Planning Commission

Agenda

Thursday, October 16, 2025

Charlie's Place
Map 072I, Group B, Parcels 1.01, 2.00,
3.00, 4.00, and p/o 10.00

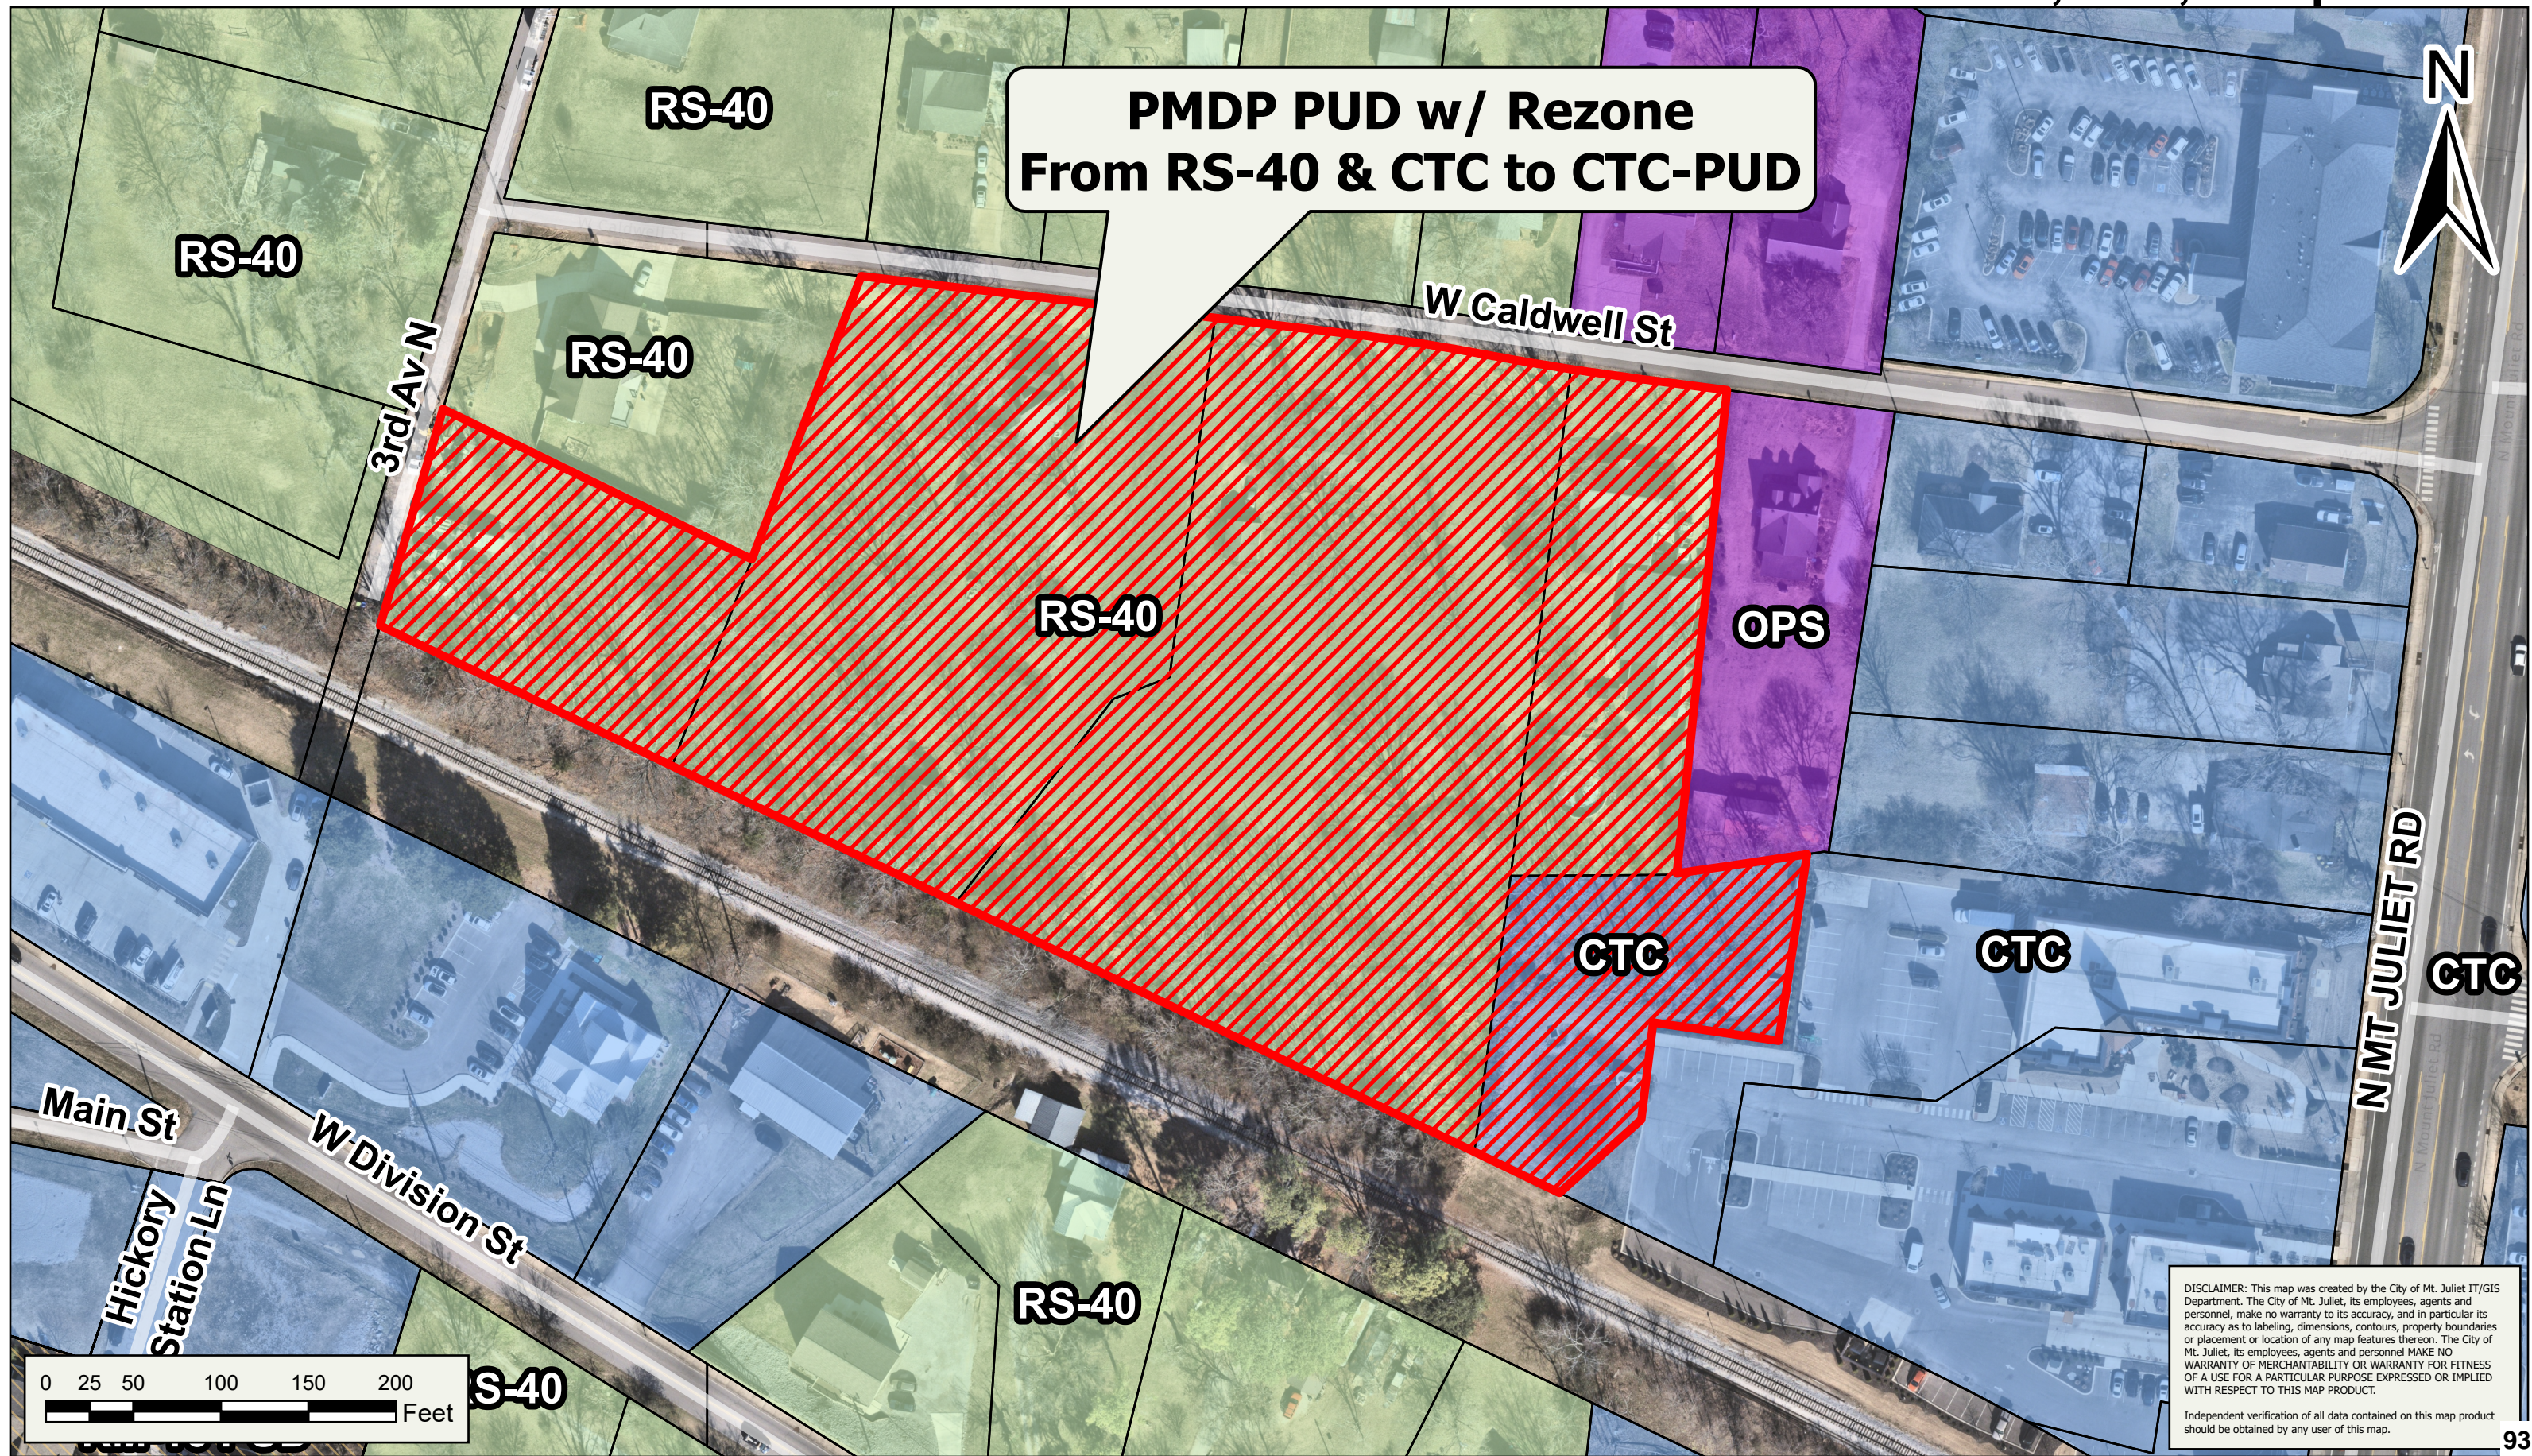
1. There are no water lines shown.

Courtyard At McFarland
5025 Old Lebanon Dirt Road
Map 077, Parcel 001.00

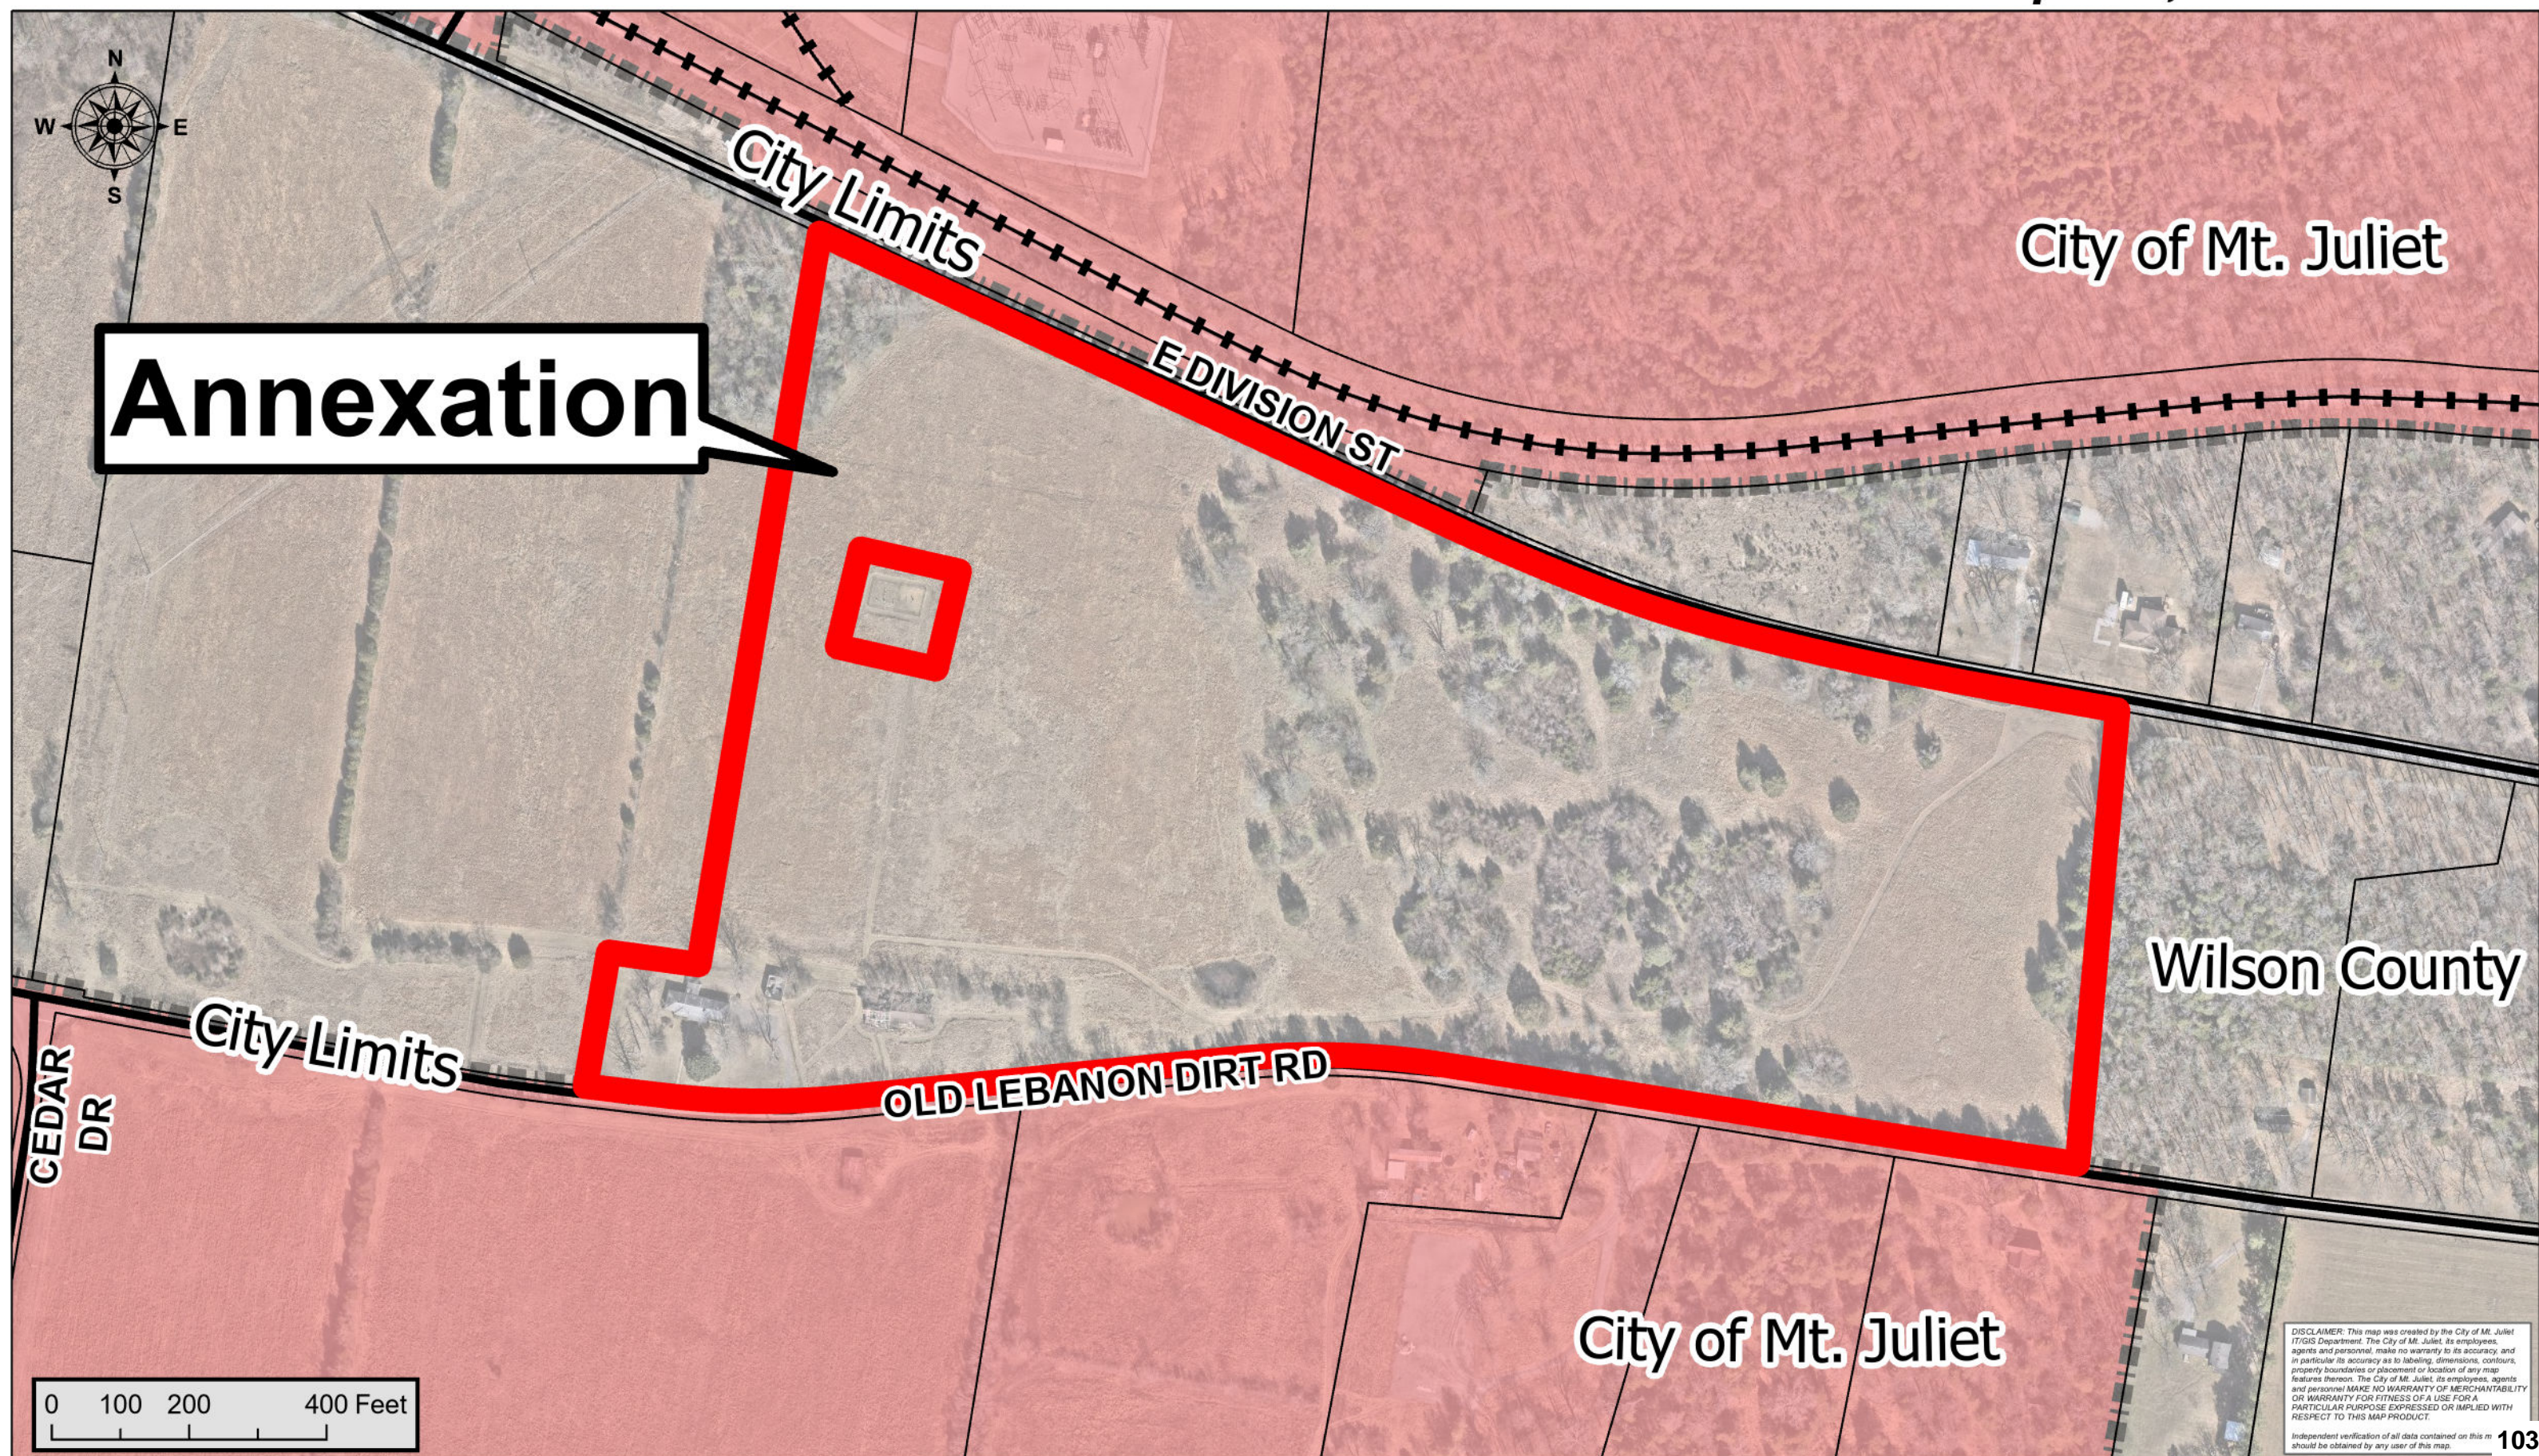
1. The water lines shown are not WWUD's design.
2. Roadway improvements shown will require water line relocations.
